Florida Department of Transportation

ROADWAY DESIGN BULLETIN 14-13

SUBJECT: **Guardrail Systems**

This bulletin provides revisions and additional requirements for guardrail systems.

Figure 4.3.1 Placement of Curb-Barrier Combinations

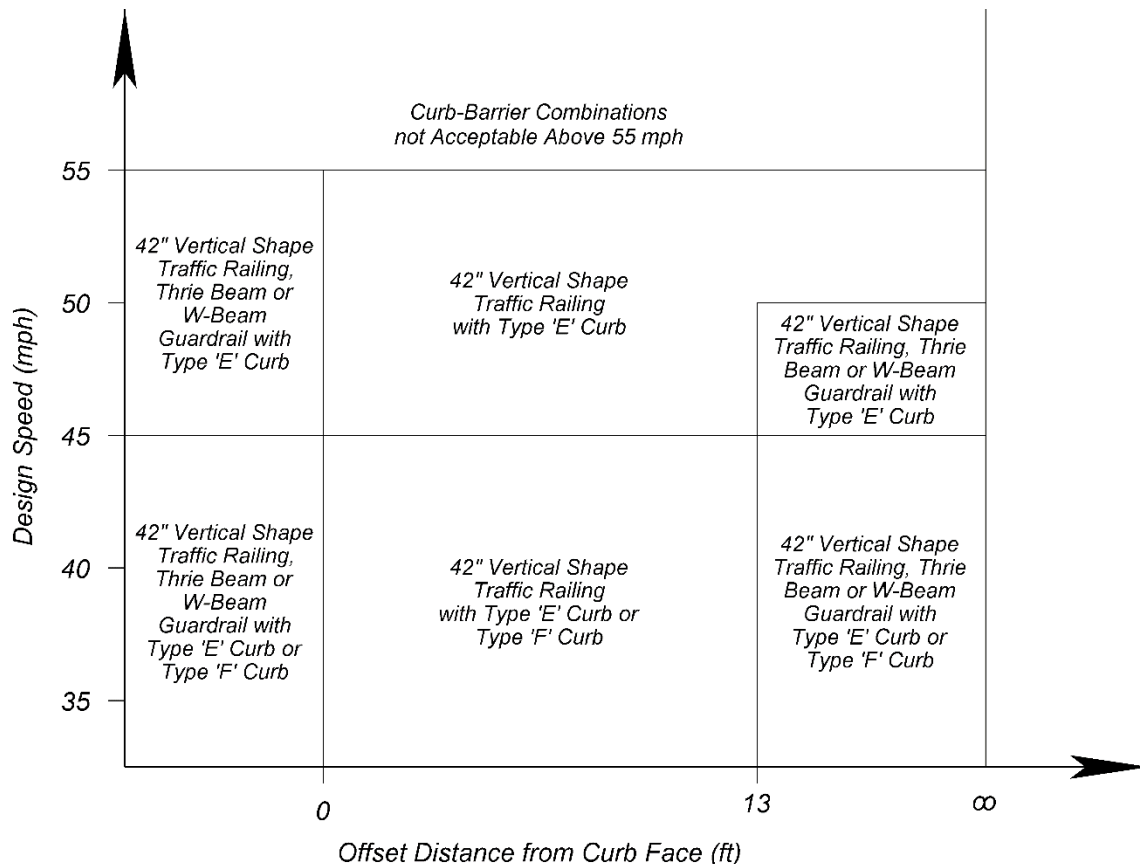
A single W-beam guardrail at a 1'-9" mounting height was tested in the study used to develop the design chart in Figure 4.3.1. This design chart has been updated for 42" Vertical Shape Traffic Railing, Thrie-beam guardrail and W-beam guardrail at a 2'-1" mounting height. Within the design chart, there is a region between 0 feet and 13 feet (approx. 4 m) behind the face of the curb where guardrail should not be located. A 42" vertical shape traffic railing (See *Design Standards* Indexes

422 and 6120) may be used in any of the locations applicable to Figure 4.3.1. The preferred configuration is to place barriers at the face of curb.

6. Delete *Plans Preparation Manual*, Volume 1, Chapter 4 – Figure 4.3.1 and replace it with the following:
